PUD-02-013

**REZONING: R-4 TO PUD
BAPTIST ROAD RETAIL CENTER
WAL-MART SUPERCENTER**

A request by Kenneth H. Barber, Uwe Schmidt and Beverly B. Miller for approval to rezone a parcel from the R-4 (Planned Development) Zone District to the PUD (Planned Unit Development) Zone District for the purpose of accommodating a Wal-Mart Supercenter store and associated Pad sites. The 30-acre property is located south of Baptist Road and east of Interstate-25 in the Tri-Lakes Planning Area. Tax Schedule #: 71360-02-023.

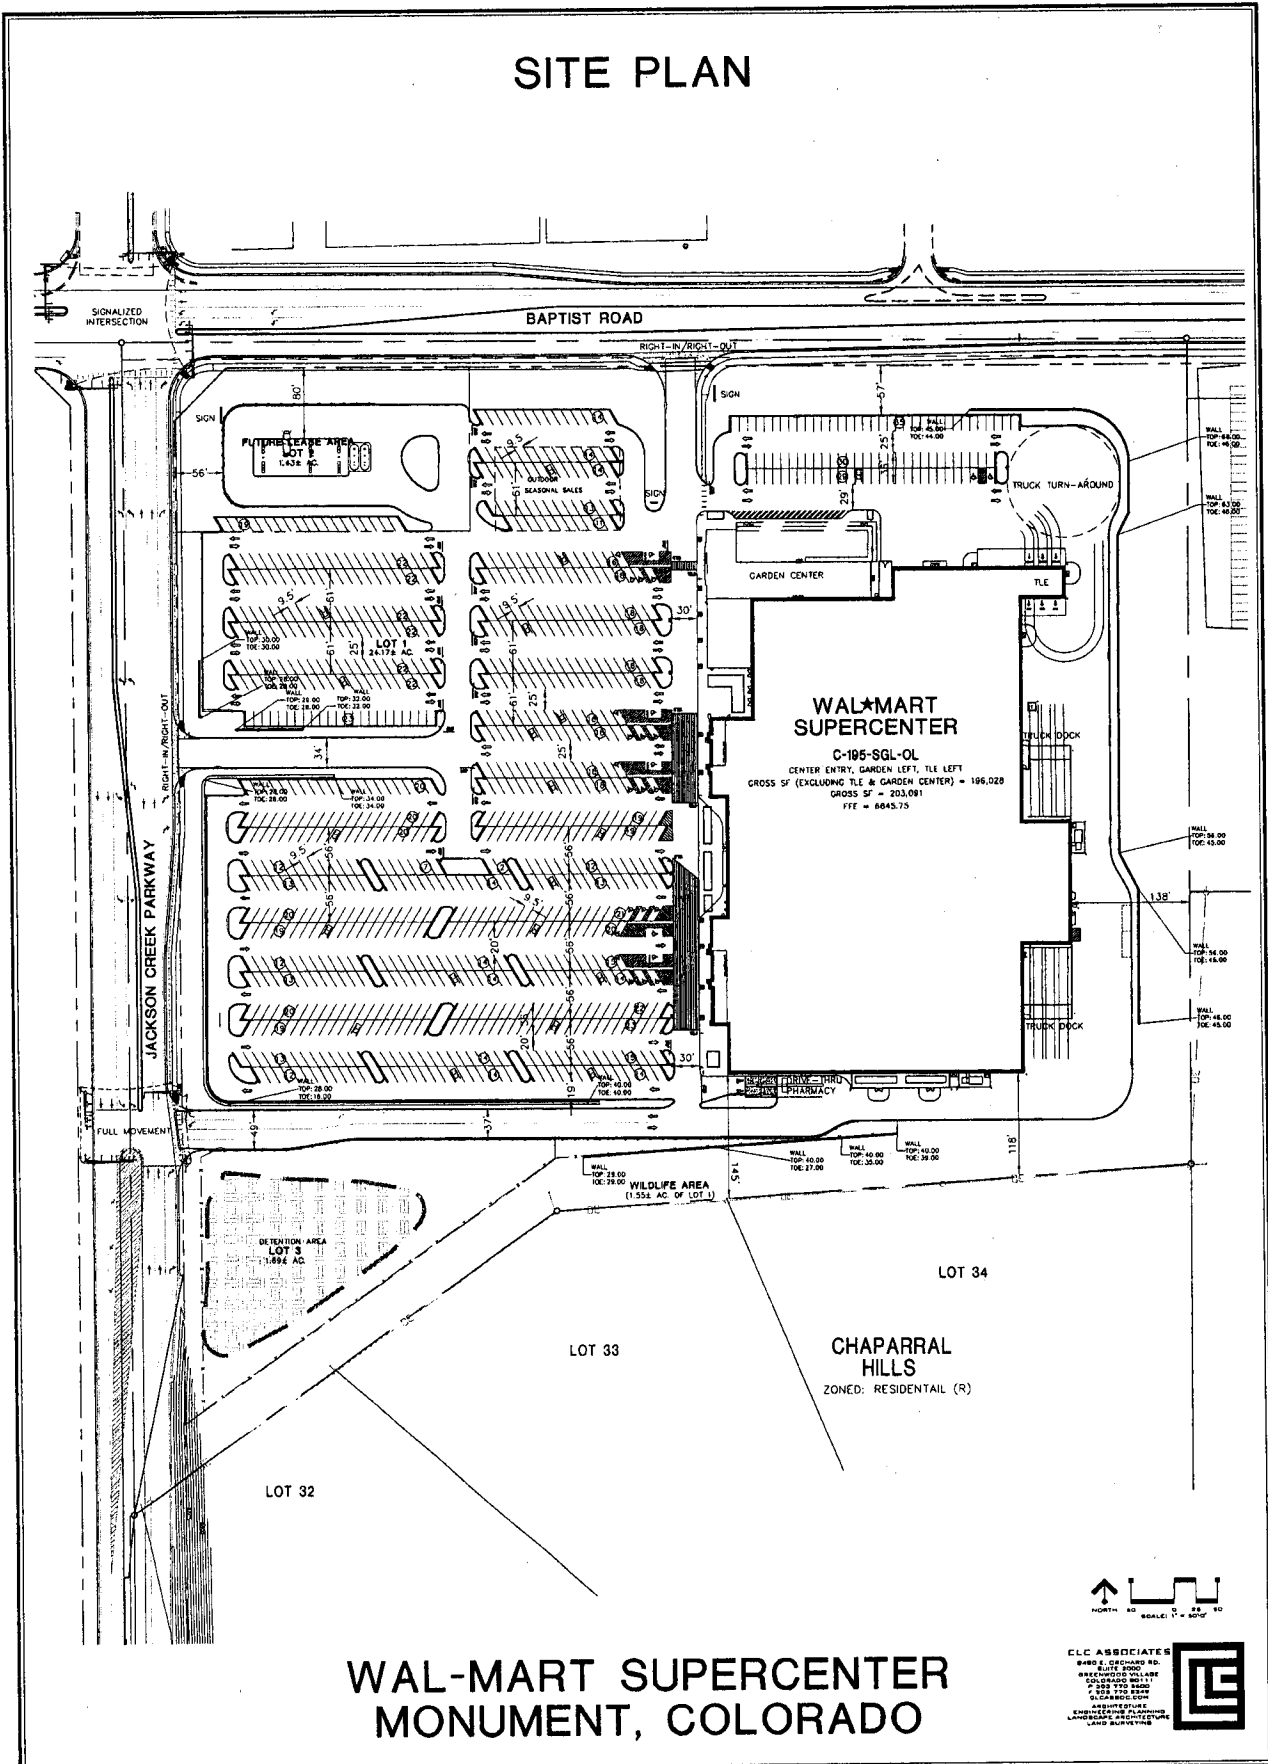
An observer on the lot south of the church, Lot 35 of Chaparral Hills Subdivision is standing approximately 15 feet lower than the church at the lot's north property line, approximately 6 feet higher than the parapet walls. This observer will also look out over the top of the parapet wall but will unlikely see the rooftop ventilation units. From the center of the lot looking northwest, the observer will likely see the back corner of the building wall with associated landscaping. Looking west and south, the observer will have an unobstructed view of the front range mountains.

An observer on the lots to the south of the building, Lots 32, 33, and 34 of Chaparral Hills Subdivision, looking north, will be located at approximately the same elevation as the finished floor of the building. The observer will look down on the detention pond and at grade at the landscaping and building side. The screenwall will obstruct the view of the condensers on the south side of the building. Looking west and south, the observer will have unobstructed views of the front range mountains.

CLC Associates will prepare visual perspectives from some of these lots for review at the Planning Commission meeting.
